CCK-2979.00-1-26

UK North Farm Seedhouse

ADDENDUM #4

UK Project #: 2979.0 Seedhouse

FLOOR PLAN GENERAL NOTES

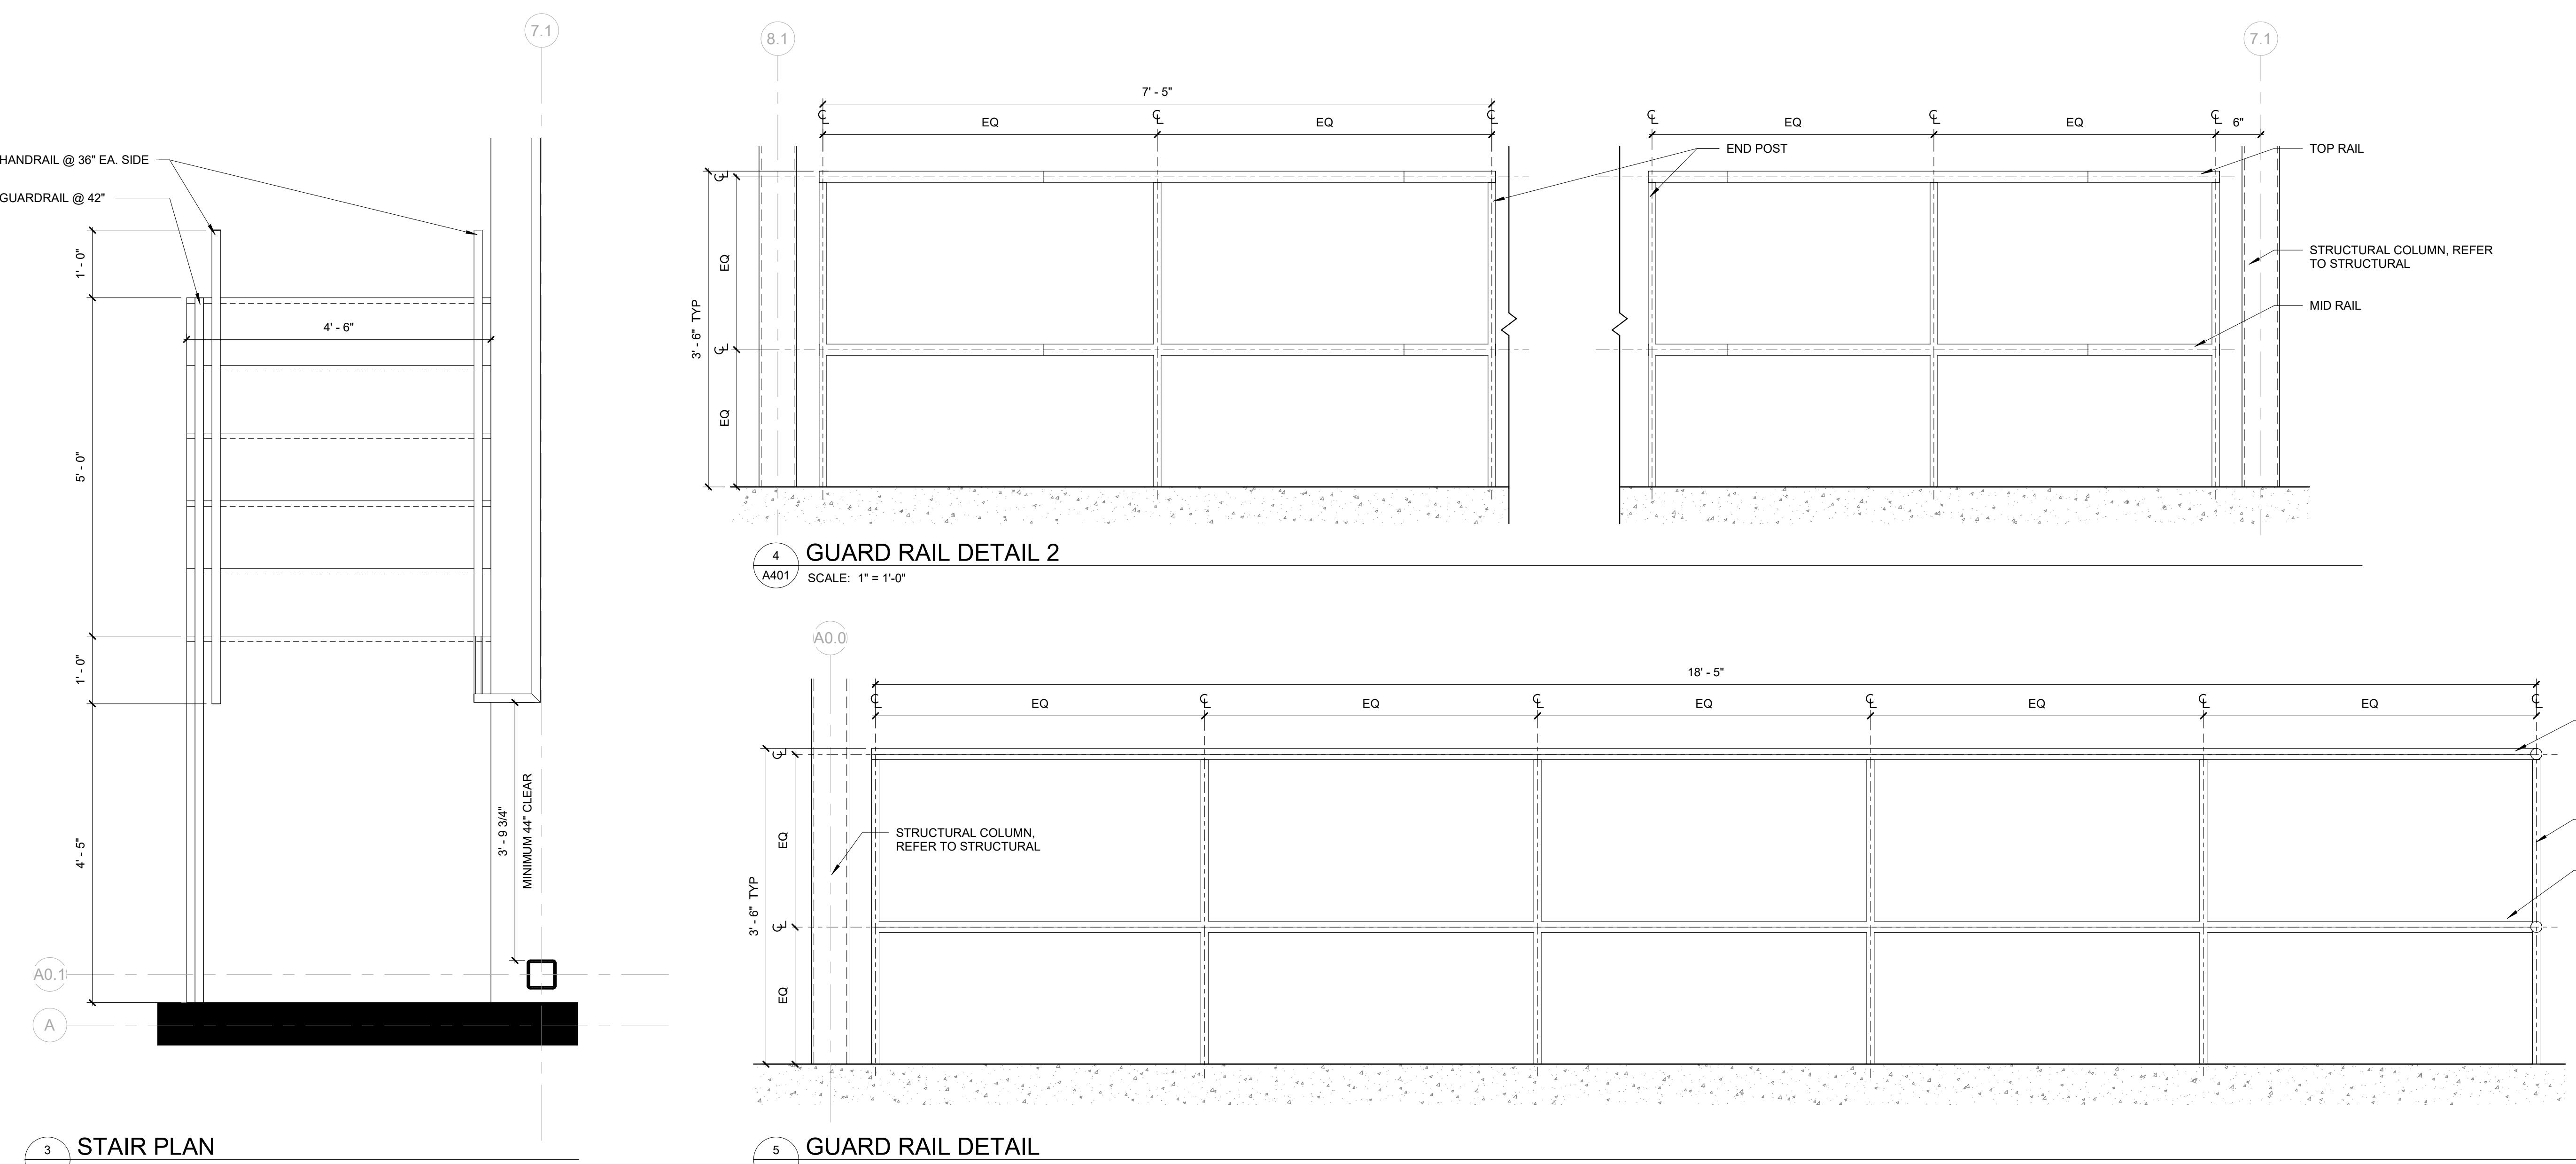
5. Refer to attached revised sheet A401 – VESTIBULE / DOCK PLANS / DETAILS.
 - a. Exterior concrete stair width changed from 4'-0" to 4'-6".
 - b. Exterior concrete stair landing width changed from 4'-0" to 4'-6".

- c. Exterior concrete stair landing length changed from 3'-11" to 5'-5".
 - d. Guardrail and Handrail extents and layout have been updated.
 - e. All Guardrails and Handrails are to be cored / embedded.

- Delete edge angle along outside edge of stair (as shown in detail P/S301).
 - No handrail is to occur along dock guardrails.
 - Stair handrails are to extend a minimum of 1'-0" beyond bottom and top treads.
